AMSTAR ENGINEERING, INC.
Structural/Civil Consultants
707 River Road
Austin, Texas 78734
(512) 263-3661
Fax (512) 263-7916

Ref: Structural Inspection
240 Canterbury Dr.
Project No. 1954

You have indicated that Mr. Christopher Copeland has issued a rebuttal to your complaint that you filed against him at the Texas Board of Professional Engineers. You have asked that I review the wood truss drawing that Mr. Copeland submitted to the Board. You provided a copy of that drawing and I have appended it to this letter as Exhibit "B".

EXHIBIT B

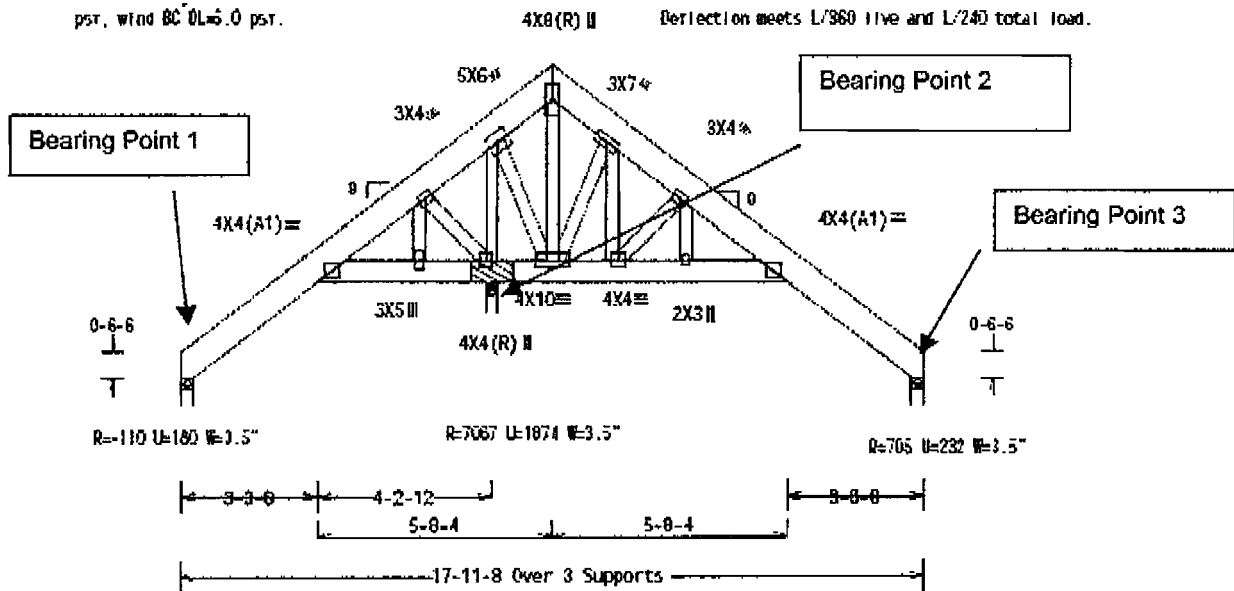
Exhibit "B" appears to be a "cut and paste" reproduction of a computer generated truss diagram dated November 3, 2004 and bearing the seal of Mr. Fred Kampmann, PE. The Kampmann-sealed diagram is attached as Exhibit "C".

2. Exhibit C has been cut and pasted onto Mr. Copeland's response letter (with Mr. Kampmann's seal removed), and submitted to TBPE very recently as part of his response to your complaint. It is not the "truss repair" diagram. Note the diagram depicts the top portion of a load bearing wall supporting the bottom chord of the truss near the middle of the truss span. That wall represents the interior wall of the bedroom. This particular wall is currently bearing down on the floor truss system at the second floor portion of your house. It is also causing much of the problem with overloading the floor system that MLAW comments on in Exhibit "D". It is also the same diagram that I included in my report, dated November 20, 2008, in which I sought calculations to be provided by MLAW to prove that the truss repair being proposed by MLAW had been designed in accordance with proper engineering standards (Exhibit "F"). Exhibit "C" depicts the existing, unrepaired truss as it sits in your house today and that is continuing to cause damage to the second floor trusses of your home.

EXHIBIT C
 EXHIBIT 23

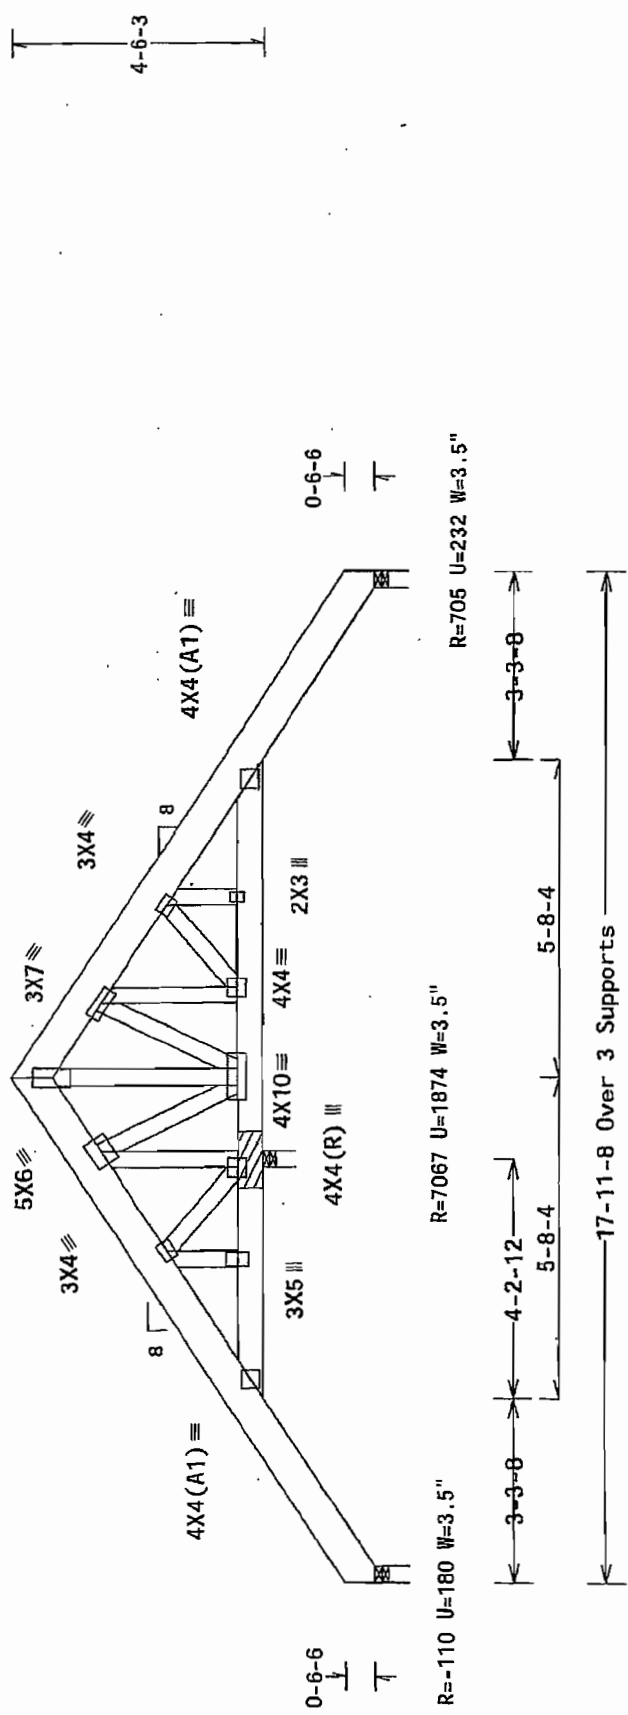
1. The existing truss is shown in Exhibit "C" and was PE sealed by Mr. Kampmann on November 3, 2004. The diagram depicts the load bearing wall. Mr. Copeland issued Exhibit "C" and I included it in my November 20, 2008 report as Exhibit 23.

5. When you compare the details of the existing truss in your house (Exhibit C), with the details of Mr. Copeland's truss repair, you can see that many of the connector plates have different sizes, with Mr. Copeland showing 7x8 connector plates near the support points of the truss whereas the existing connector plates are only 4x4. Metal connector plates have metal teeth that mash into the wood and hold the members together – the larger they are, the greater the resistance of the members to being pulled apart. There are other changes to the connector plate sizes. Mr.

EXHIBIT 25

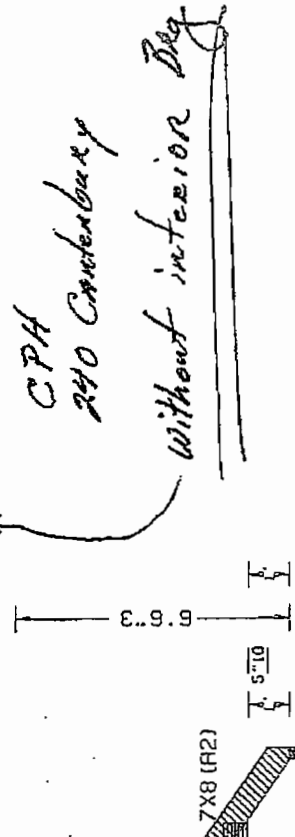
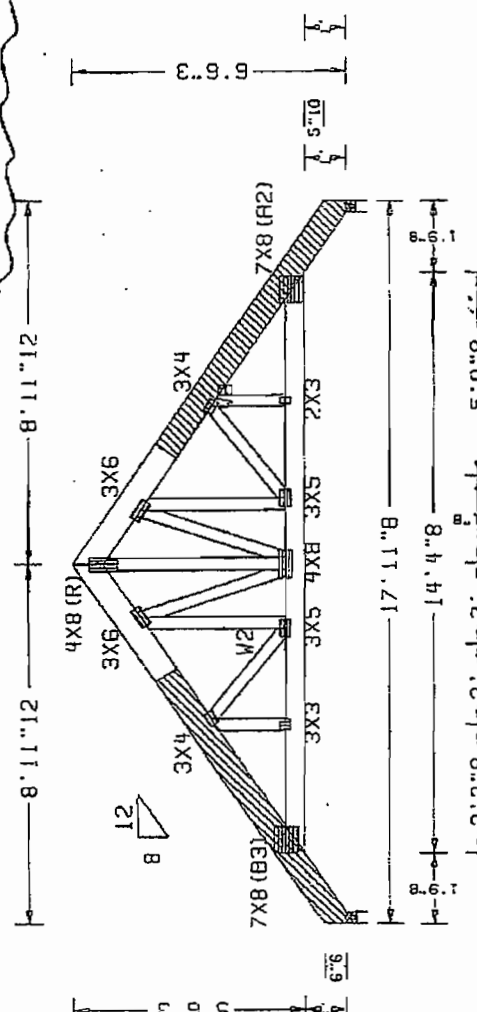
3. On May 25, 2007, MLAW issued the report containing the repair plan that is shown in Exhibit "E". This repair plan does not have Mr. Kampmann's PE seal and there is no logo depicting Alpine. As presented, it is the work of Mr. Copeland and MLAW. The repair plan is dated May 18, 2007 and was submitted to me in the May 25, 2007 report under seal of Mr. Copeland. This is the detail that I relied on in my report dated November 20, 2008 and is the same detail as Exhibit "25" from my report.

4. Exhibit E depicts both theory as well as a repair. Exhibit E shows that the load bearing bedroom wall acting as a support point has been removed. In actuality, what I understand that MLAW was trying to accomplish was an effort to stiffen up the existing truss and perhaps remove a top portion of the wall, including wall sheetrock, to take this truss load off the middle wall. Engineering statics dictates that this load from the roof has to find a way to the foundation, and so Mr. Copeland's theory was evidently to transfer the loads to the end walls shown at both ends of the truss. In doing this, the truss span becomes longer than originally designed since it no longer has a near-mid-span bearing point and it must span a greater distance from wall to wall. This means that the stresses in the truss are much greater than before and the existing truss must be substantially reinforced or completely replaced. This solution ignored the previous damage that had already been caused to the second floor trusses which certainly benefitted the builder when it provided cost of repairs to your house.

Copeland is calling for a change in size of the connector plates, but provides no calculations to show how he arrived at those sizes. Since the girder truss depicted actually consists of two trusses mashed together, and connector plates are attached on both faces of each individual truss, this repair cannot be accomplished inside the attic as depicted in Exhibit E because the connector plates at the touching faces cannot be reached. Mr. Copeland admits that he is not qualified to perform truss calculations (Exhibit G), yet he applied his PE seal to a report containing Exhibit E. I know that he has pled that others gave him the numbers, but that doesn't matter because you, I and the rest of the general public relied on his seal and it is evident that Mr. Copeland does not know if any numbers are actually correct and he has failed to protect the public.
